UNITED STATES PATENT AND TRADEMARK OFFICE

APPLICATION NO.	FILING DATE	FIRST NAMED INVENTOR	ATTORNEY DOCKET NO.	CONFIRMATION NO.
10/709,661	05/20/2004	Bertil Jonsson	07589.0175.PCUS00	3039

Office Action Summary

DETAILED ACTION

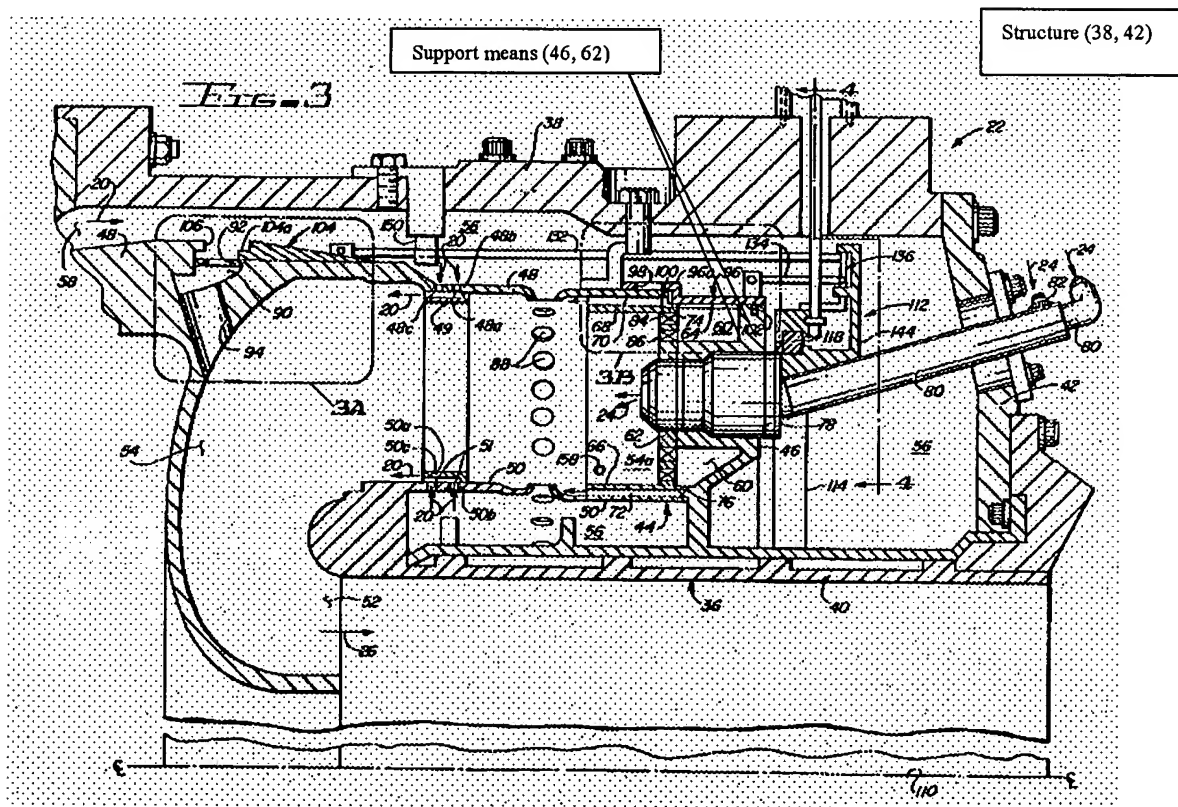
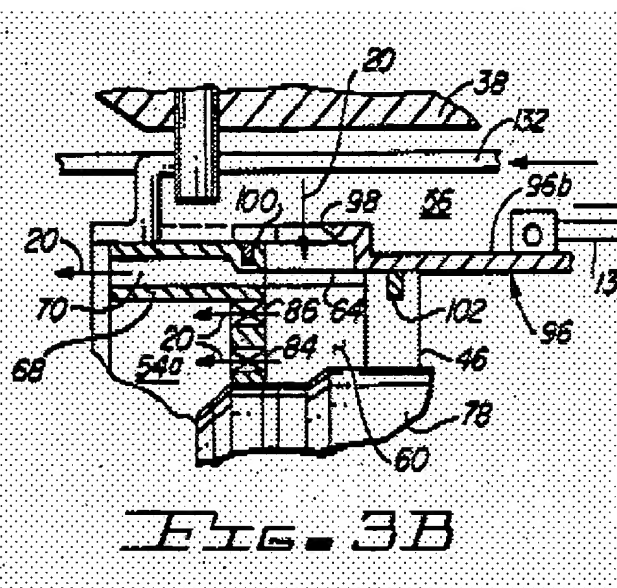
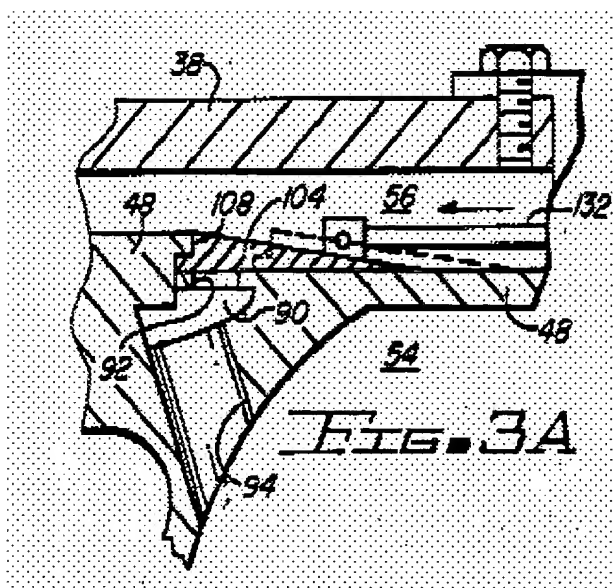
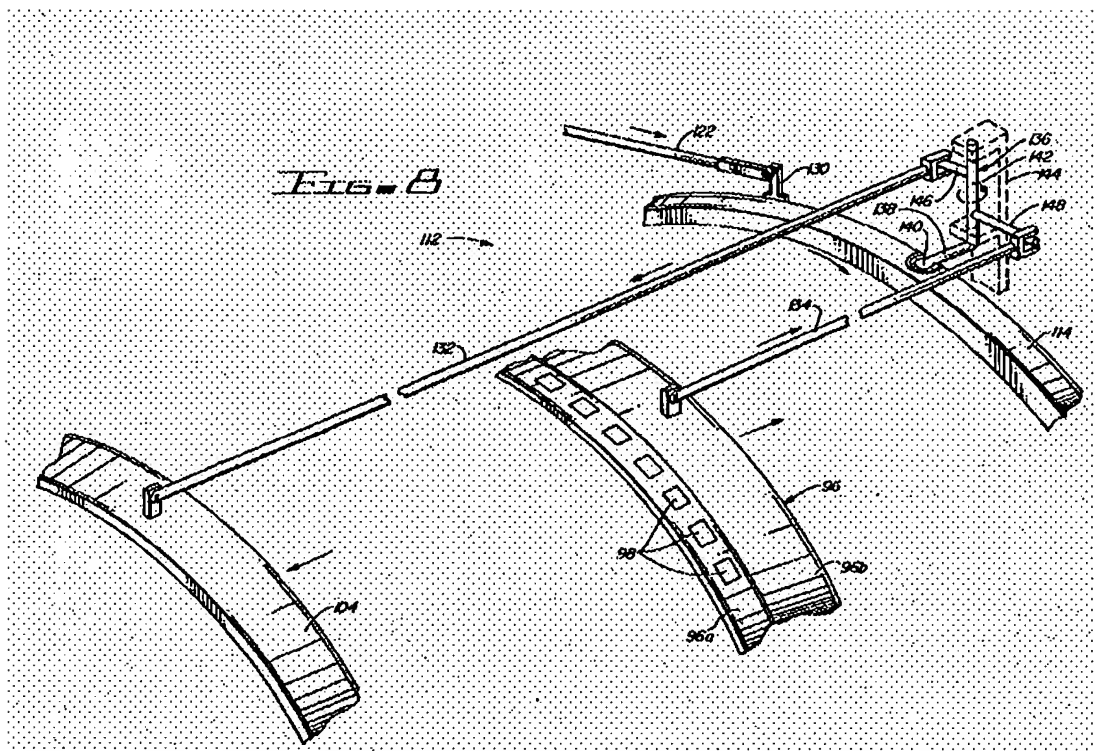
With respect to claim 23, **Mongia** teaches a device for controlling the intake of gas into a combustion zone of the combustion chamber of a gas turbine, said device comprising: a control element arranged outside the combustion chamber; said control element further comprising a first cover means (96) for covering at least a first inlet (64) to the combustion zone, said first cover means being displaceable relative to the combustion chamber, and a support means (46, 62) connected to the first cover means for providing support to the control element, said support means being accommodated interiorly within a structure (38, 42) rearwardly located with respect to the combustion chamber and said support means being substantially concentrically oriented relative to a centerline of the combustion chamber. See particularly **Figures 3, 3a, 3b and 8** above; and column 5 line 59 to column 6 line 22.

With respect to claim 24, **Mongia** teaches that the control element is exclusively supported on said support means (46, 62) in an operating configuration, without contact with the combustion chamber. See particularly **Figure 3** above.

With respect to claim 26, **Mongia** teaches that the structure (38, 42) in which the support means is accommodated forms at least a part of a combustion chamber cover. See particularly **Figure 3** above.

With respect to claim 27, **Mongia** teaches that the support means, when accommodated in the structure is radially oriented outside a pilot distributor (78) to the combustion chamber. See particularly **Figure 3** above.

With respect to claim 29, **Mongia** teaches that the support means has a circular cross-sectional shape. See particularly **Figure 3** above.

With respect to claim 31, **Mongia** teaches that at least one recess (98) in the first cover means and first inlet 64 to the combustion chamber, when in registration with one another, are configured to form a through-duct for gas passing from outside the combustion chamber to inside the combustion chamber. See particularly **Figure 3b** above.

With respect to claim 38, **Mongia** teaches that the first cover means is arranged at a greater radial distance from a central axis through the control element than the support means (46, 62). See particularly **Figure 3** above.

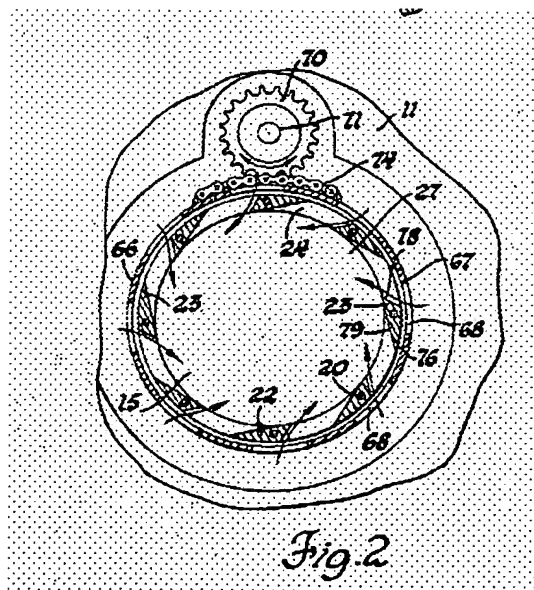
With respect to claim 30, **Mongia** teaches that the first cover means has at least one recess (98) extending through a wall thereof in a substantially radial direction of the control element. See particularly **Figure 8** above.

With respect to claim 34, **Mongia** teaches that the wall of the first cover means is ring-shaped and said at least one recess (98) extends therethrough. See particularly **Figure 8** above.

With respect to claim 39, **Mongia** teaches that the first inlet 64 extends through a combustion chamber wall and forms a gas inlet into at least one swirl (84, 86) arranged in the combustion chamber. See particularly **Figure 3** above.

With respect to claim 40, **Mongia** teaches that the control element further comprises a second cover means (104) configured to cover at least a second inlet (92) to the combustion zone, the at least one second inlet being arranged at a distance from the at least one first inlet in a longitudinal direction of the combustion chamber. See particularly **Figure 3b** above.

With respect to claim 45, **Mongia** teaches that the second cover means is connected to the first cover means by at least one arm (142). See particularly **Figure 8** above.

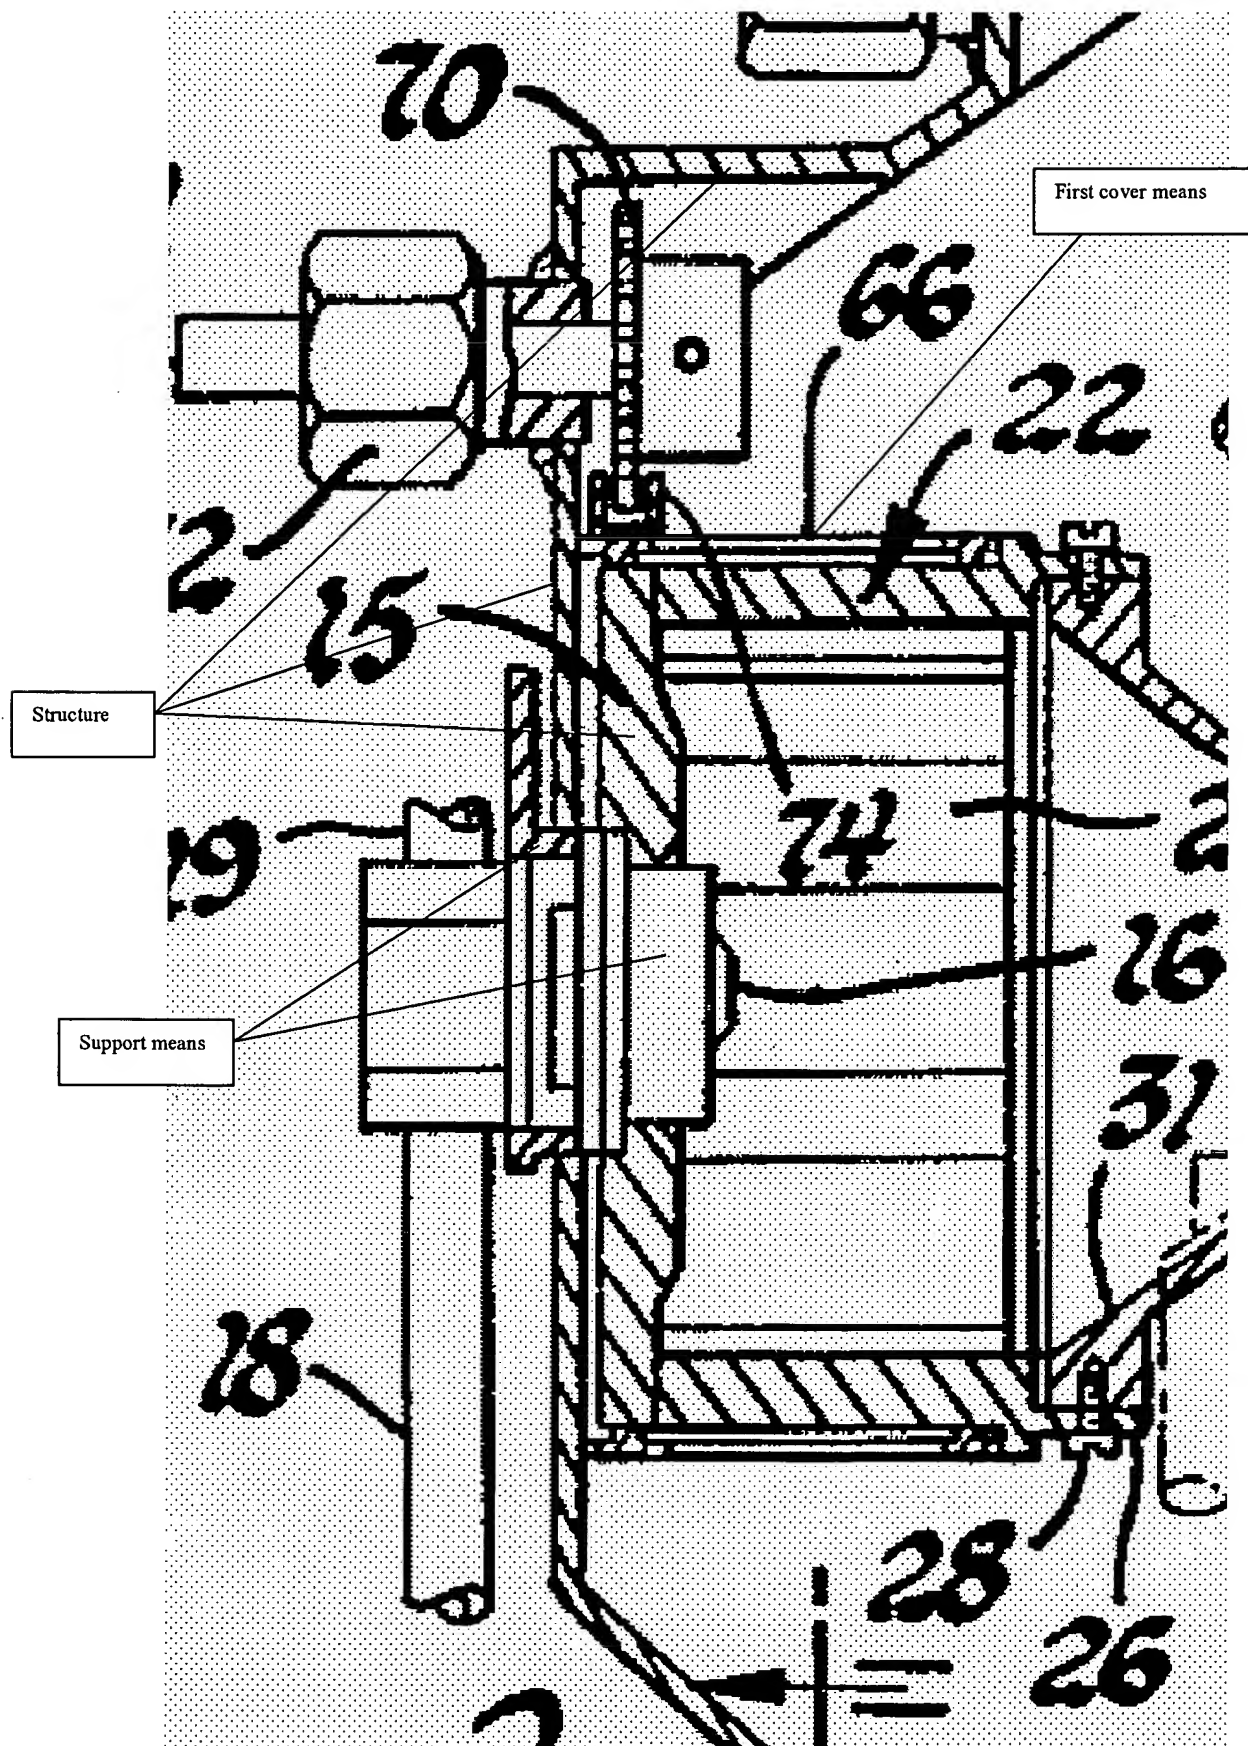
With respect to claim 23, **Cornelius** teaches a device for controlling the intake of gas into a combustion zone of the combustion chamber of a gas turbine, said device comprising: a control element arranged outside the combustion chamber; said control element further comprising a first cover means (66) for covering at least a first inlet (24) to the combustion zone, said first cover means being displaceable relative to the combustion chamber, and a support means (16) connected to the first cover means for providing support to the control element, said support means being accommodated interiorly within a structure (11, 15) rearwardly located with respect to the combustion chamber and said support means being substantially concentrically oriented relative to a centerline of the combustion chamber. See particularly **Figures 1 and 2** above.

With respect to claim 24, **Cornelius** teaches that the control element is exclusively supported on said support means in an operating configuration, without contact with the combustion chamber. See particularly **Figures 1 and 2** above.

With respect to claim 26, **Cornelius** teaches that the structure in which the support means is accommodated forms at least a part of a combustion chamber cover. See particularly **Figures 1 and 2** above.

With respect to claim 29, **Cornelius** teaches that the support means has a circular cross-sectional shape. See particularly **Figures 1 and 2** above.

With respect to claim 30, **Cornelius** teaches that the first cover means has at least one recess (68) extending through a wall thereof in a substantially radial direction of the control element. See particularly **Figure 2** above.

With respect to claim 31, **Cornelius** teaches that at least one recess (68) in the first cover means and first inlet 24 to the combustion chamber, when in registration with one another, are

On page 9 applicant argues that "Cornelius'413 does not disclose a support means connected to the first cover means for providing support to the control element, said support means being accommodated interiorly within a structure rearwardly located with respect to the combustion chamber". However, as clearly shown on marked-up Figure 1 of **Cornelius** (see page 7 of this office action), **Cornelius** does teach the limitations being argued, that is, **Cornelius** discloses a support means (16) connected (indirectly through element 15) to the first cover means (66) for providing control for the control element, said support means (16) being accommodated

interiorly within a structure (See marked-up Figure 1 above) rearwardly located with respect to the combustion chamber.

Element 16 of Cornelius provides indirectly at least some support to the first support means 66.

Element 66 is inserted within the structure (15, 11).

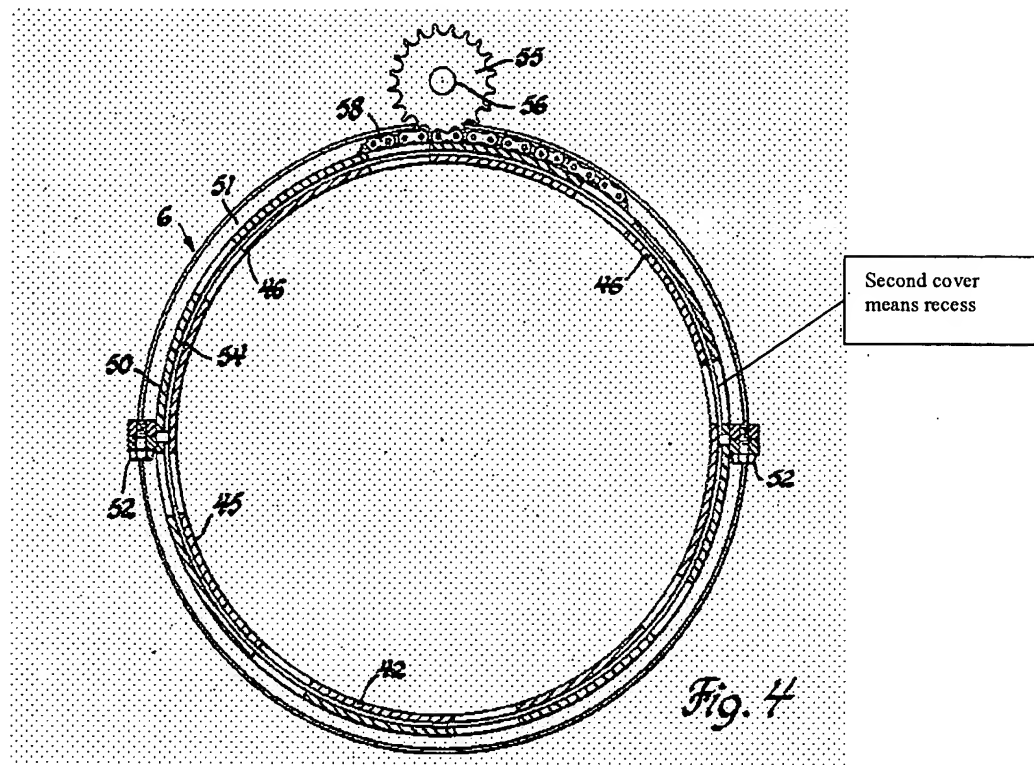
With respect to claim 40, **Cornelius** teaches that the control element further comprises a second cover means (50) configured to cover at least a second inlet (46) to the combustion zone, the at least one second inlet being arranged at a distance from the at least one first inlet in a longitudinal direction of the combustion chamber. See particularly **Figure 4**.

With respect to claim 41, **Cornelius** teaches that the second cover means has at least one recess that extends in a substantially radial direction through a wall thereof. See particularly **Figure 4**.

With respect to claim 42, **Cornelius** teaches that at least one recess in the second cover means and the second inlet (46) to the combustion chamber, when in registration with one another, are configured to form a through-duct for gas passing from outside the combustion chamber to inside the combustion chamber. See particularly **Figure 4**.

With respect to claim 43, **Cornelius** teaches that the second cover means is in the shape of a ring with said at least one recess extending through a wall thereof. See particularly **Figure 4**.

With respect to claim 44, **Cornelius** teaches that the second cover means is rotatable relative to the combustion chamber. See particularly **Figure 4**.
